14-UP-2020

DC Ranch Neighborhood Park MUMSP Phase I

Subject: 14-UP-2020 DC Ranch Park site going to Planning Commission - no provision for mitigation off-site flows

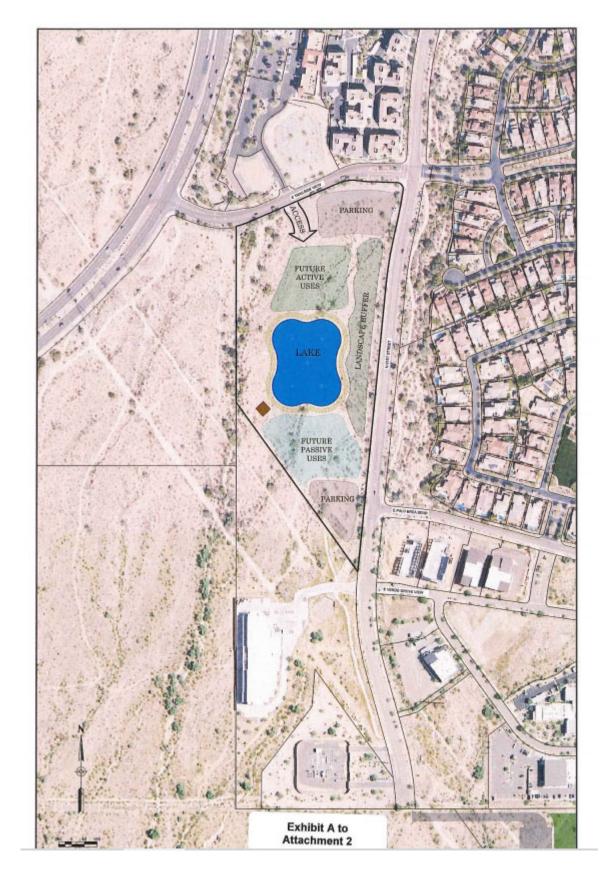
onto ASLD property

Bell Road Sports Complex Concept Plan

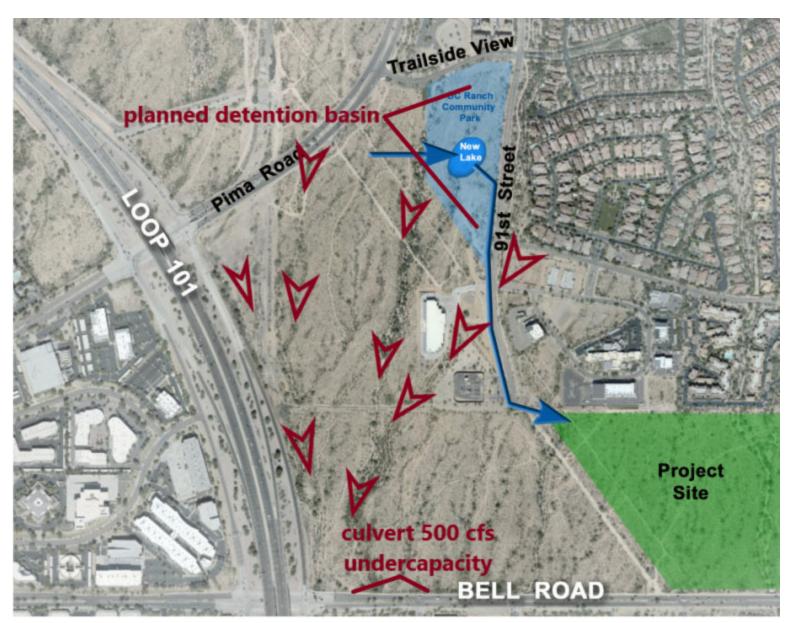
The plan below basically constructs a lake to provide irrigation to the Bell Road Sports Complex. The staff report doesn't mention any drainage considerations and the city's historical proposal since 2007 to utilize the park site also as a detention basin to mitigate the significant off-site flows resulting in an undercapacity (500 cfs) of the culverts at Bell/101. If that plan is not implemented, there needs to be some other alternative that doesn't encumber the 125-acre ASLD property which is planned to be auctioned shortly.

: The DC Ranch Park site has been identified by Stormwater staff since 2007 for dual-use as a stormwater detention basin to mitigate the significant culvert undercapacity at Bell/101. The Bell Road culverts have a capacity of approximately 900 cfs and the 100-yr event is approximately 1,400 cfs. The lake concept may be in conflict with the necessary basin.
